Subject: Submittal of Topical Report BAW-10199P, Addendum 1, "The BWU Critical Heat flux Correlations," December 2000.

SUBJECT: ACCEPTANCE FOR REFERENCING OF LICENSING TOPICAL REPORT BAW-10199P, ADDENDUM 1, "THE BWU CRITICAL HEAT FLUX CORRELATIONS" (TAC NO. M96728)

SAFETY EVALUATION BY THE OFFICE OF NUCLEAR REACTOR REGULATION

BAW-10199P-A, The BWU Critical Heat Flux Equations, Addendum 1:
Appendix E -- Application of the BWU-Z CHF Correlation to the Mark B11 Spacer Grid Design
Appendix F -- Application of the BWU-Z CHF Correlation to the Mark BW17 Fuel Design with Mid-Span-Mixing Grids

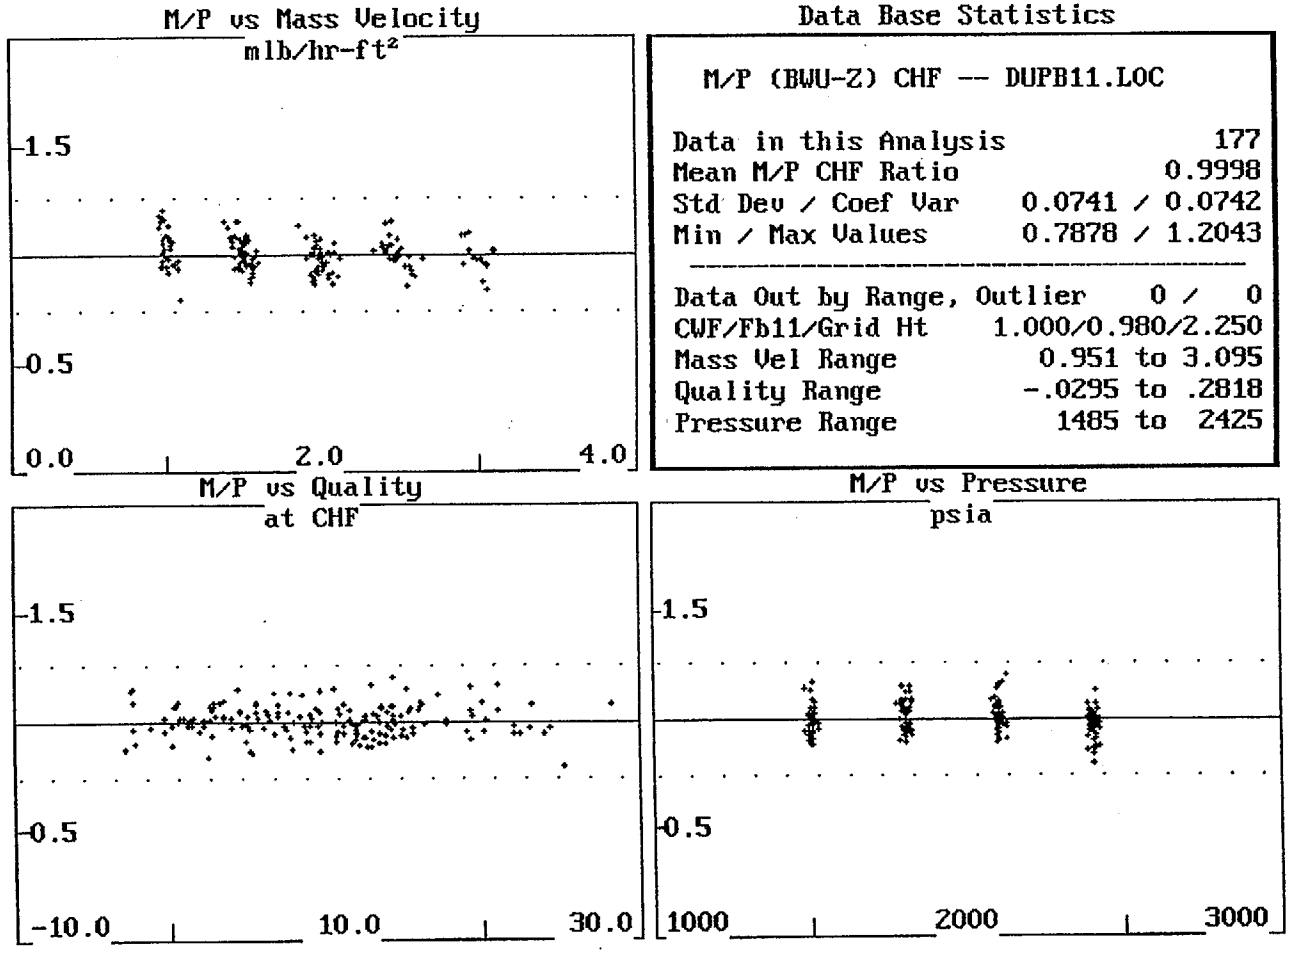
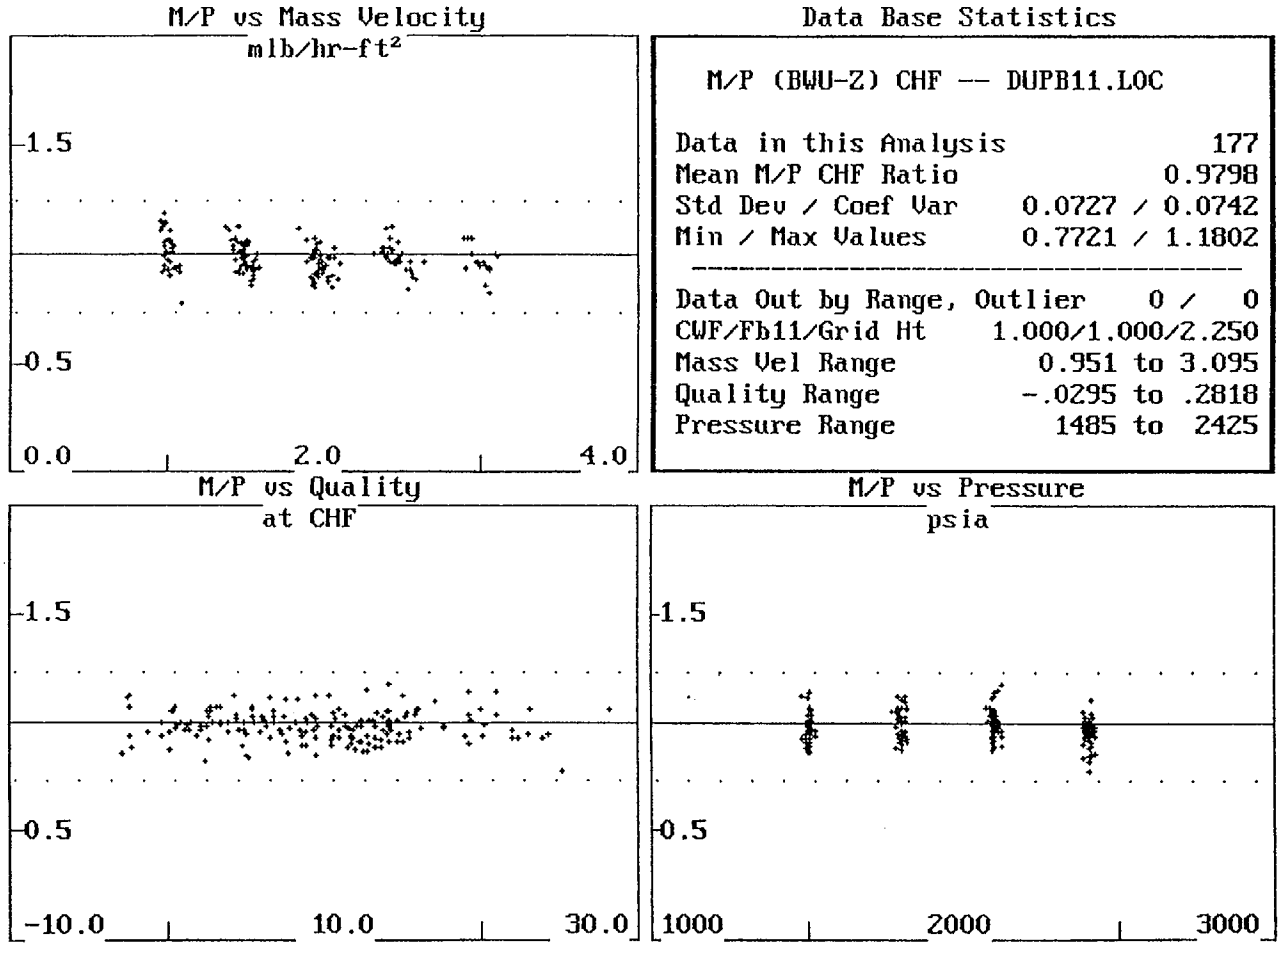
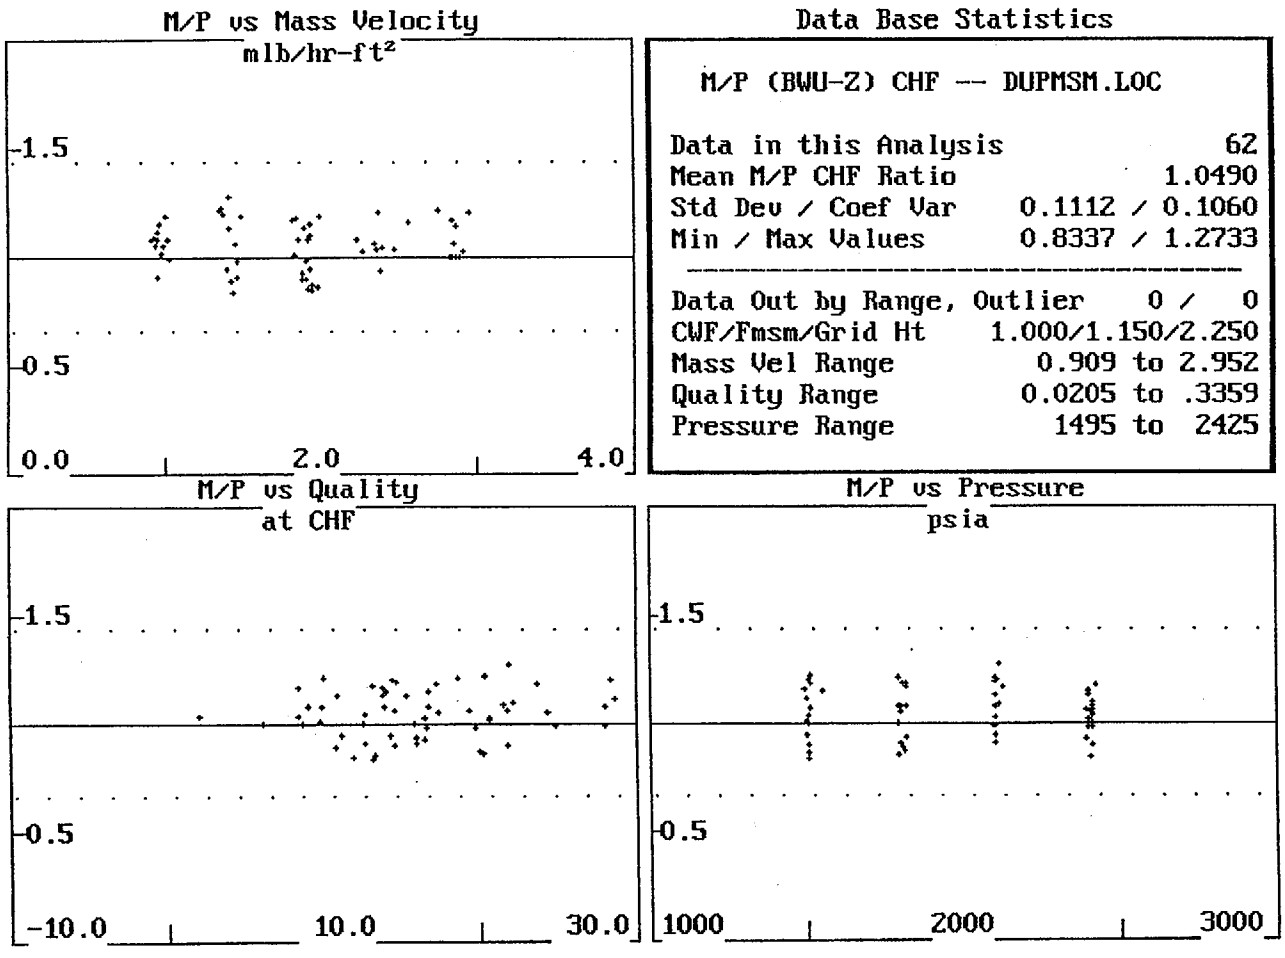
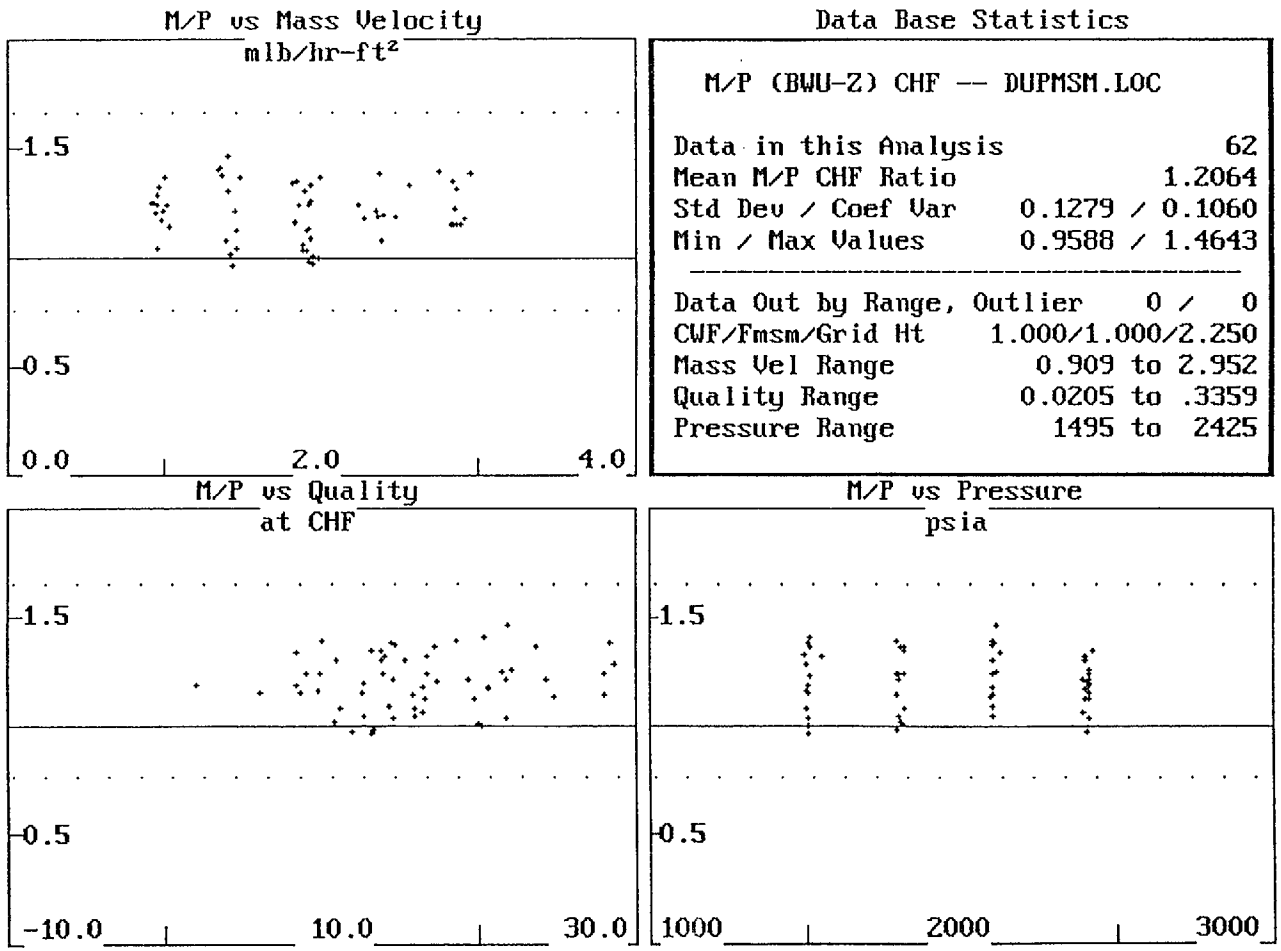
1. The response to Question 3 dated February 23,1998, states that no bias was found when the B11 and BW17-MSM data bases were analyzed with the BWU-Z correlation, and only the "average levels" were different. Please provide information supporting this conclusion, in the form of

Figures Q1a-1 and Q1a-2 show summary bias plots of the Mark B11 replicate data set with F_{B11} = 0.98 and 1.0 respectively. Figures Q1a-3 and Q1a-4 show these summary bias plots for the Mark BW17-MSM replicate data set with F_{MSM} = 1.15 and 1.0 respectively. Finally, for reference, Figure Q1a-5 shows the summary bias plots for the replicate Mark BW17 data base of 411 data. It should be noted that the change in F_{B11} = 0.98 to 1.0 merely raises each M/P value on the summary bias plots by 2 percent uniformly (i.e., the predicted CHF, P in the M/P value, is multiplied by 0.98). Likewise the change in F_{MSM} = 1.15 to 1.0 lowers the values uniformly by 15 percent. F_{B11} and F_{MSM} are simple normalization factors. The corresponding normalization factor for the Mark BW17 data base is, of course, 1.0. Thus any bias with respect to the independent variables can be seen regardless of the F_{B11} or F_{MSM} values.
